Critical Areas Questions for permit #2112-249

I am the wetland biologist hired by Edward and Catherine Moran for their single-family residential development proposal at 5028 West Mercer Way (see attached screen shot for location). I am working on providing the additional streams and stream buffers information for their critical areas review and I have some questions for you.

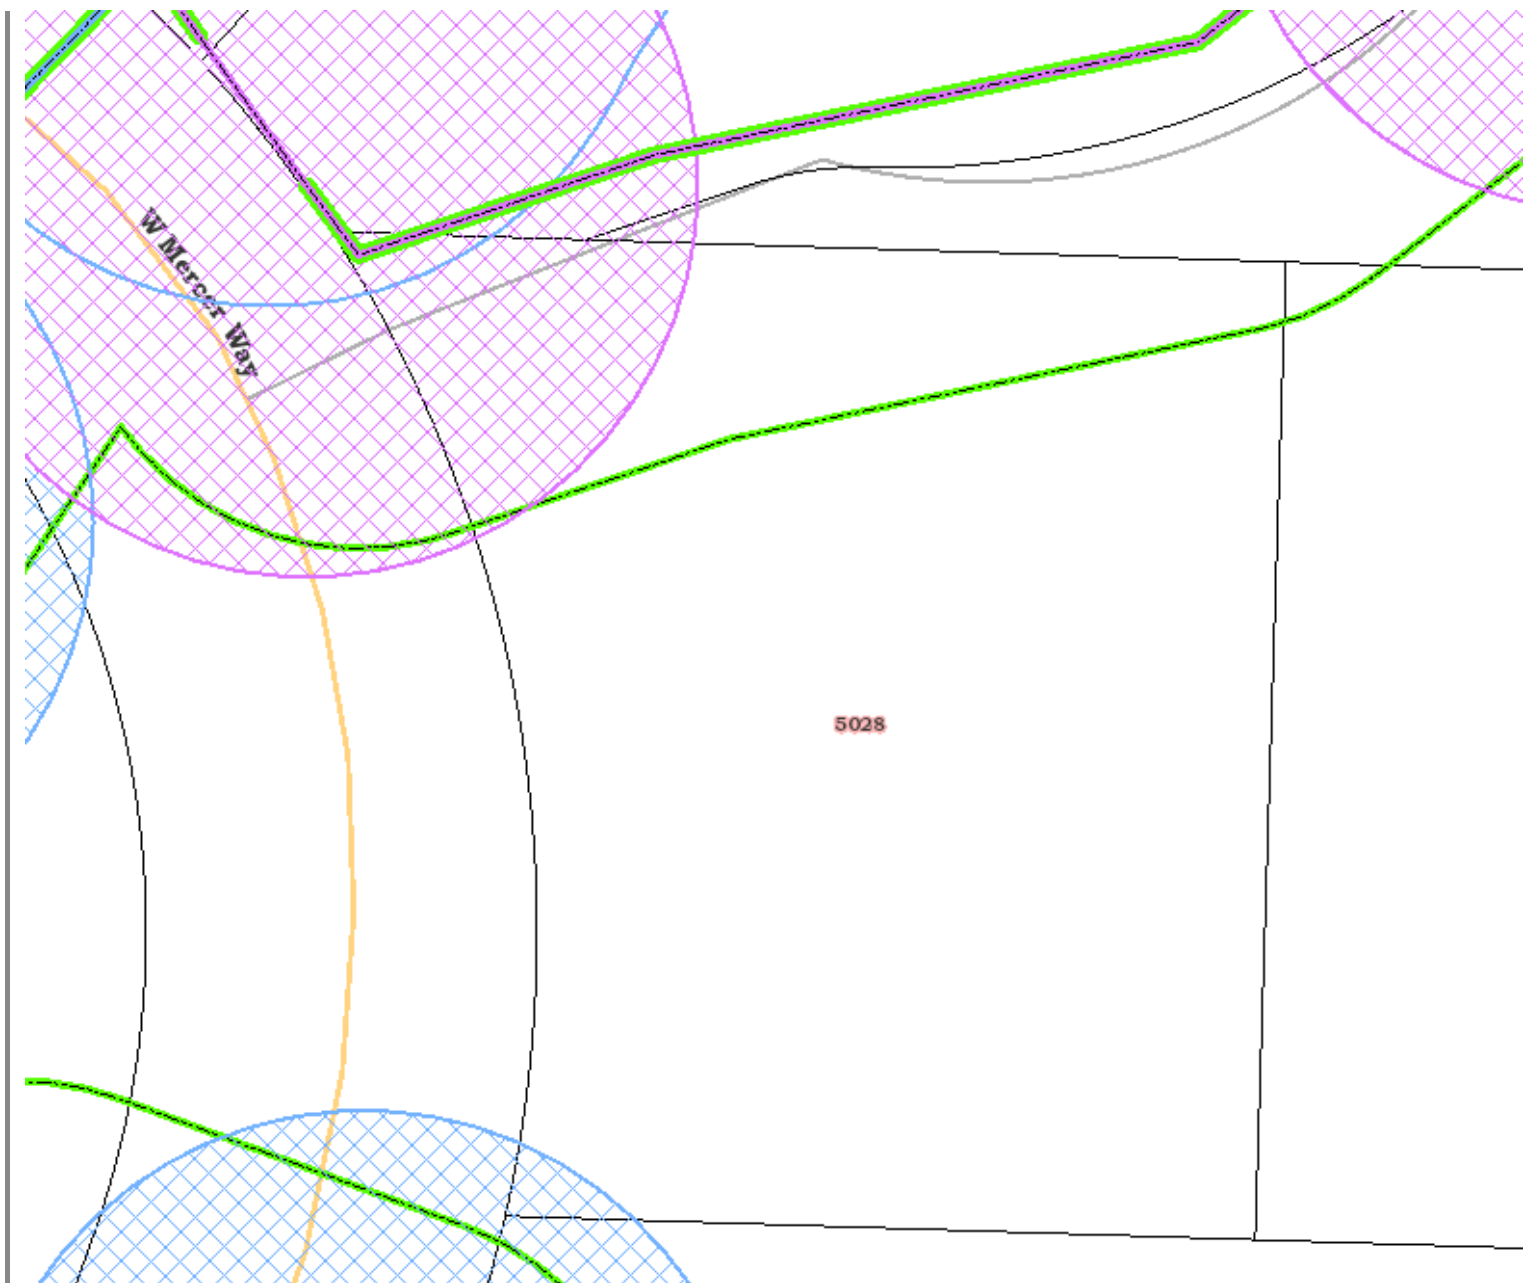
1) There is a piped, seasonal stream section (purple) running beneath the off-site access driveway to the north of my clients property. I verified this feature on the ground. It is completely piped along the north side of the property and it follows a pretty significant gradient under the north side of the driveway. Your code states that piped streams or stream sections do not have buffers; however, I was told by the architect on this project you communicated to him that because this stream could in theory be day lit someday you will regulate it as an un-piped stream and apply a buffer anyway. I wanted to check if this info was correct? That would mean you are applying a 60’ buffer to a piped stream section that does not have a functional buffer. Additionally, if it were ever day lit it would mean the driveway access to this cluster of homes and portions of the residential landscaping would have to be removed. In this particular stretch of stream this does not seem to be a real option for future restoration. Not without a take on several private properties along this driveway access.

The City of Mercer Island GIS shows that there are two segments of watercourses that affect this property (see below):

- A Type Ns Watercourse along West Mercer Way. This watercourse segment requires a 60-foot buffer (purple hashed area in the screenshot below). Lot coverage and hardscape is not allowed within the watercourse buffer and structures must be set back 10 feet from the edge of the buffer. Buffers may be averaged or reduced under the provisions set forth in MICC 19.07.180(C)(4) and (5), respectively. Please note that if you are proposing buffer averaging or reduction, a Critical Area Review 2 (CAR2) is required. Prior to accepting a CAR2 application, a pre-application meeting is required.

- A piped Type Ns watercourse. This watercourse does not have a buffer, but it does have a 50-foot setback (area within the green lines in the screenshot below). The piped watercourse setback is intended to leave room for the piped watercourse to eventually be daylighted. Daylighting may not be feasible in all circumstances, but the setback is still required in case future development allows it. Please refer to MICC 19.07.180(C)(6) for the regulations for piped watercourses. There are provisions for reducing the piped watercourse setback. Note that the buffer for daylighted sections of piped watercourses is 15 feet, not 60 feet as you state above.
